## **Re: Beaches Link and Gore Hill Freeway Connection - Environmental Impact Statement (EIS)**

### **This submission is on behalf of Save Manly Dam Catchment Committee (SMDCC)**

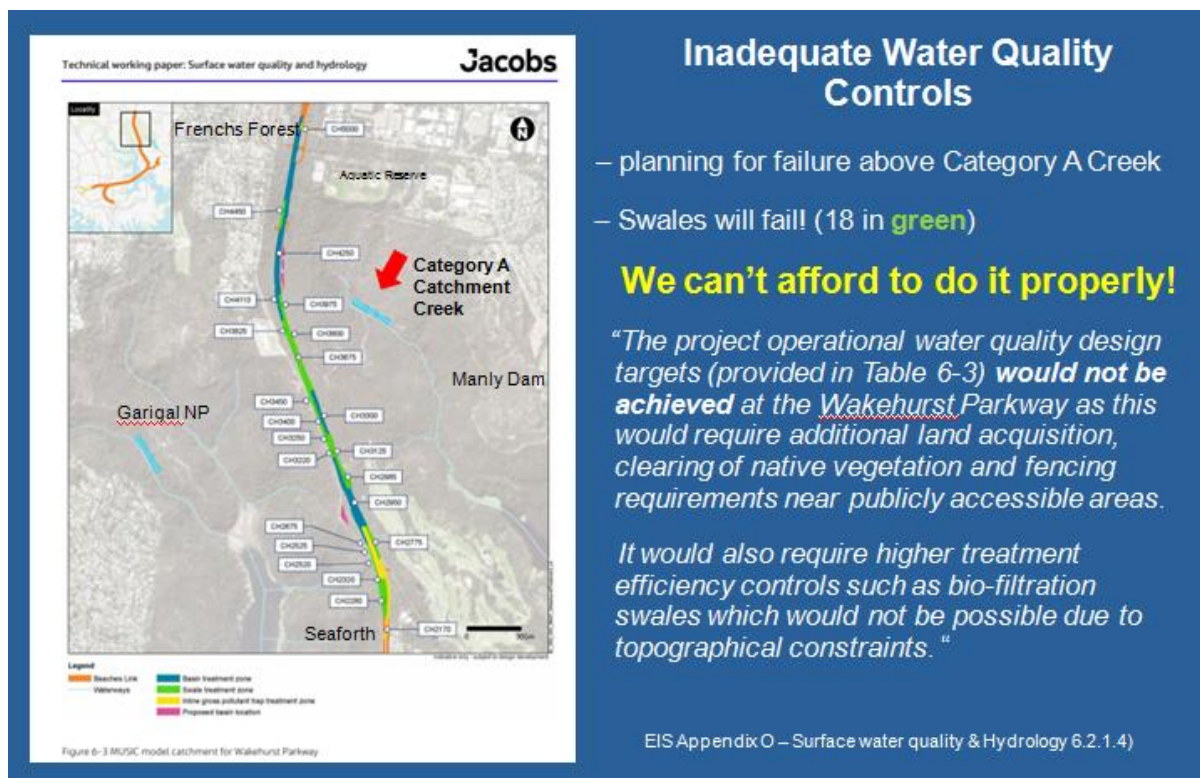
Using your statistics it would have failed every month in 2020 against Terry Hills weather data – 35 mm over 5 days. Please re-design/re-investigate suitable drainage processes to protect this special area before asking for any approvals.

We are very concerned that proposed water quality measures will be insufficient as witnessed at Mona Vale Rd, Manly Vale PS and NB Hospital Road widening. TfNSW even state that they would not achieve water quality design targets. The swales will most likely fail at the most critical point into Curl Curl Creek (Category A creek) and drain into the catchment. Sediment impacts throughout. There is no analysis of the scouring and increased water velocity of the discharge of the constructed water quality ponds.

This is a cross section of Wakehurst Parkway. (Appendix v p190ish)

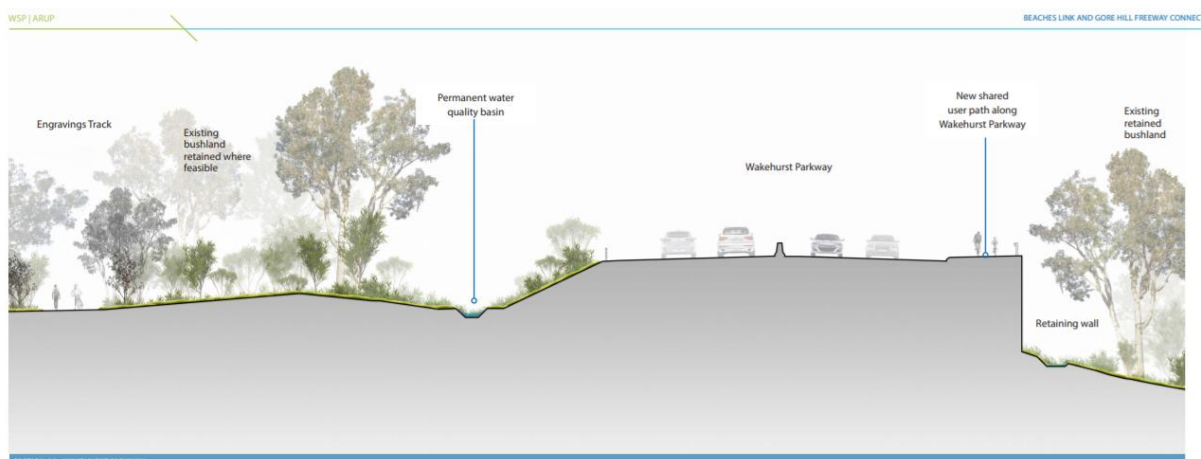
In many cases the design includes the road being metres in the air. Please explain how the water run-off will be managed adequately, how the users of the shared pathway will be safe, and what extra damage will be caused by building on an unsuitable road?

Please note the shared pathway (above the 6-10m retaining wall) with no safety features, no lights, no indication of separation from the 80km/hr vehicles.

In many cases the design includes the shared pathway being metres in the air and no protection from 80km/h travelling trucks. Please explain how the users (cyclists, pedestrians) of the shared pathway will be protected adequately?
